3333 CALIFORNIA STREET MIXED-USE PROJECT

RESPONSES TO COMMENTS ON DRAFT EIR VOLUME 1

CITY AND COUNTY OF SAN FRANCISCO
PLANNING DEPARTMENT: CASE NO. 2015-014028ENV
STATE CLEARINGHOUSE NO. 2017092053

Re: **Attached Responses to Comments on Draft Environmental Impact Report Case No. 2015-014028ENV [3333 California Street Mixed-Use Project]**

RTC FIGURE 4.2: PARCELS SURVEYED TO DEVELOP EXISTING RETAIL NEIGHBORHOOD PARKING RATE

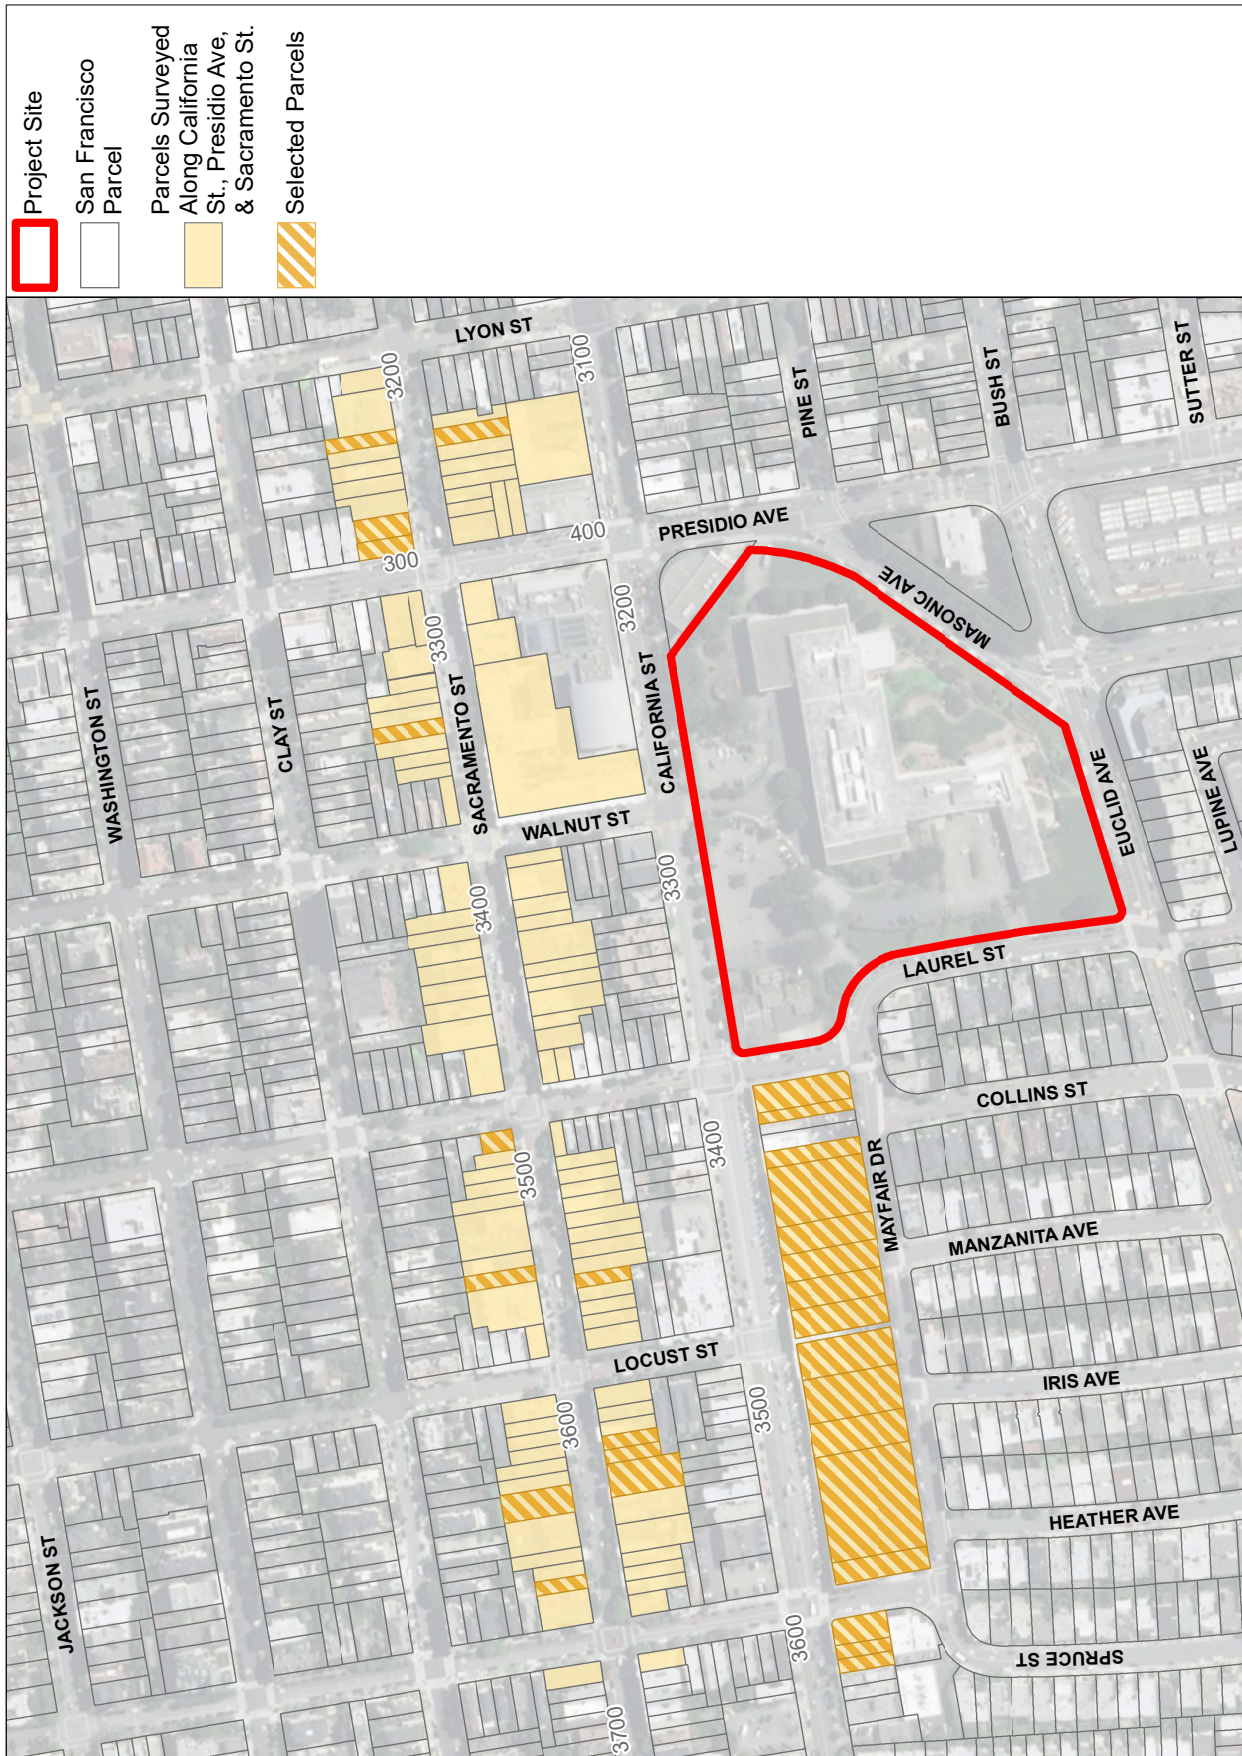
Sacramento Street near the project site.” The neighborhood parking rate for retail is 1.55 and for other non-residential uses is 1.44. The sentence ends with a footnote, which summarizes an email from Wade Wietgreffe, San Francisco Planning Department on February 20, 2018 regarding the methodology for non-residential uses. The email, which references an associated attachment, states:

Although the footnote and email text do not list Presidio Avenue, the attachment also included non-residential uses along Presidio Avenue near the project site. The parcels surveyed by the department for the retail neighborhood parking rate are shown on Figure RTC 4.2: Parcels Surveyed to Develop Existing Retail Neighborhood Parking Rate.

(REVISED) FIGURE 4.E.2: SENSITIVE RECEPTOR PARCELS IN THE IMMEDIATE VICINITY OF THE PROJECT SITE

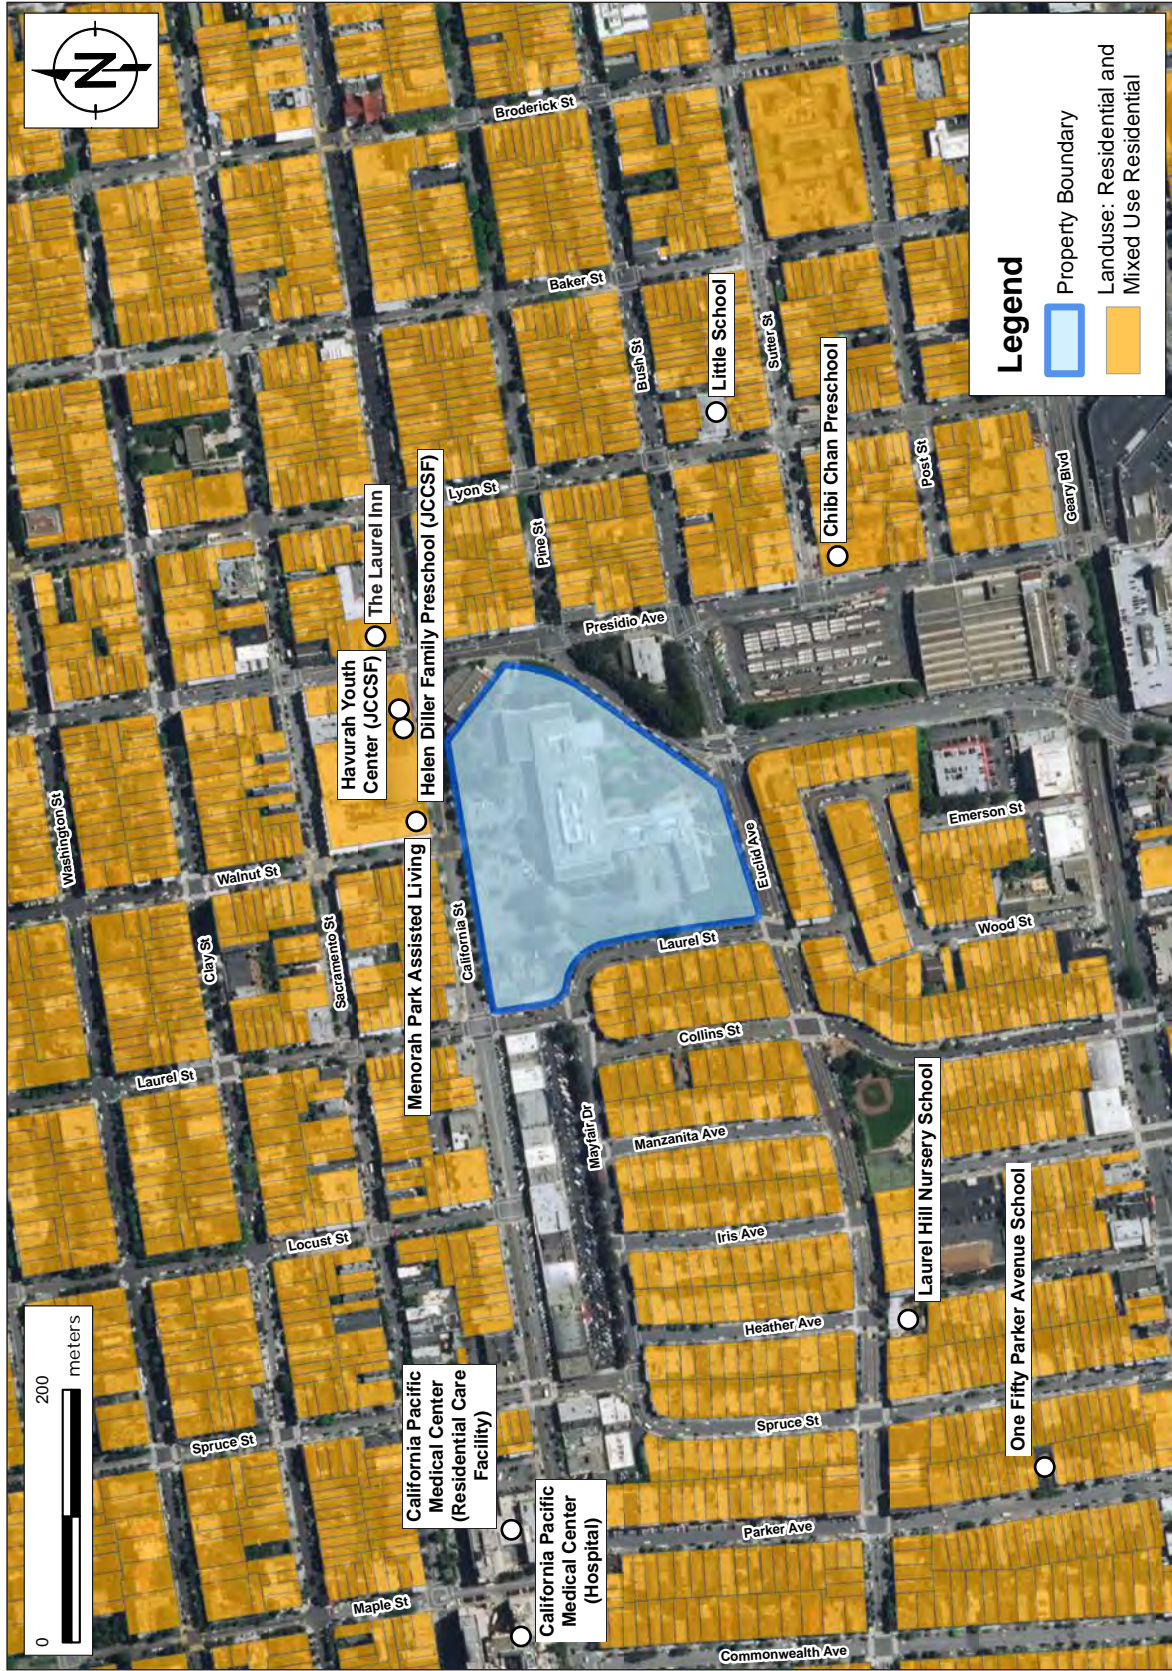
“The young children attending this pre-school would appear to be sensitive receptors. Why is the 150 Parker Avenue School not shown on the map (Page 4.E.30) below?” (*Rose Hillson, Letter, January 8, 2019 [I-Hillson2-43]*) [*Figure 4.E.2 referenced on p. 23 in Comment Letter I-Hillson2 is shown on EIR p. 4.E.30 and in RTC Attachment B.*]

The One Fifty Parker Avenue School was not included in EIR Figure 4.E.2. This figure has been revised to show this location as a sensitive land use; this revision does not affect the analysis or any results. As discussed on EIR pp. 4.E.17-4.E.18 and in Response AQ-1, pp. 5.G.3-5.G.11, all sensitive receptors shown on Figure 4.E.2 and Figure 4.E.7 such as daycare centers and hospitals were evaluated as residential land uses as a conservative assumption because residences would have longer exposure durations (compared to daycare centers and other non-residential sensitive land uses), and would therefore be expected to have greater health impacts. This is true for the One Fifty Parker Avenue School, which is over 1,000 feet west of the project site. As such, including this school on Figure 4.E.2 does not affect the location where the proposed project or project variant would have the maximum impact. See Figure 4.E.8, EIR p. 4.E.57, for the locations of the off-site and on-site maximally exposed individual sensitive receptors locations.

Figure 4.E.2, on EIR p. 4.E.30, has been revised to include a label for the One Fifty Parker Avenue School site. The revised figure is shown on the following page.
